# RESPONSE TO ABP PRE-APP OPINION

BELGARD GARDENS PHASE 1,  
BELGARD SQUARE, TALLAGHT, DUBLIN 24

**RESPONSE TO AN BORD  
PLEANÁLA PRE-APPLICATION  
OPINION**

O'Connor Sutton Cronin & Associates (OCSC) are preparing this report in response to the Notice of Pre-Application Consultation Opinion issued by An Bord Pleanála (pertaining to the case reference: ABP-301909-18) for construction of mixed use residential development consisting of 438 no apartments, 403 no. bed spaces for student accommodation, childcare facility, new roads, accesses and associated site works located at Belgard Gardens, Belgard Square North, Tallaght, Dublin 24. Specifically, this report seeks to address Items No. 1, No. 4, No. 5 & No. 6 of the issues to be addressed in the SHD application, with other items addressed by various other members of the design team and submitted under separate cover. Furthermore, as per the Strategic Housing Development Regulations this response also address points 1, 4, 5 of the An Bord Pleanála opinion which covers the specific info to be submitted with the SHD application.

Figure 15: Overview of Existing Green Areas

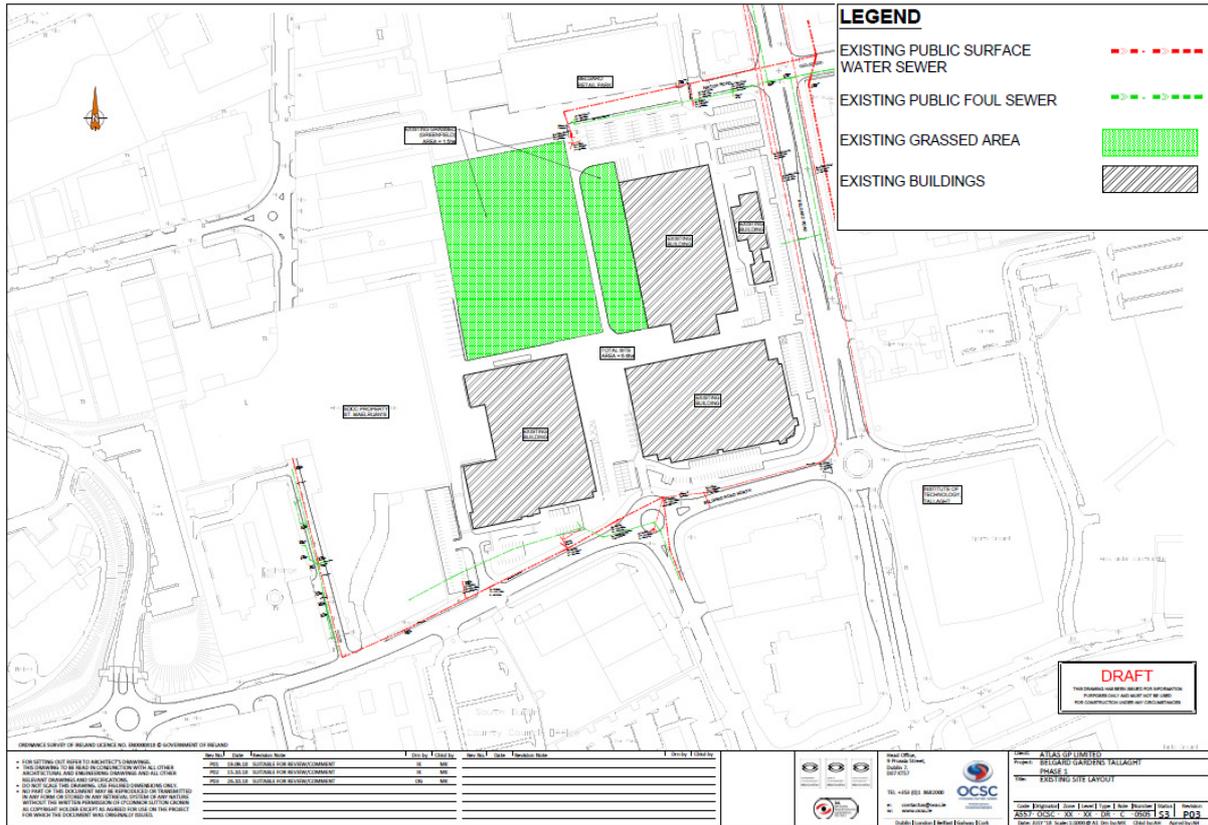
*1.1 It is unclear what proposed area is hardstanding, what proposed area is permeable area and what proposed area is greenfield with their respective runoff coefficients.*

Response: OCSC outlined, at the above referenced meeting, that a summary of the existing hardstanding area is described within **Section 3.3.1** of the **Engineering Services Report**, which outlines that approximately 75% (5-hectares) of the overall existing site area is currently hardstanding with the remaining 25% (approximately 1.6 hectares) being green open space. This is also shown on OCSC drawing **A557-OCSC-XX-XX-DR-C-0505**, which provides an overview of the existing site area. This drawing was also presented at the noted meeting and subsequently emailed to SDCC drainage department.
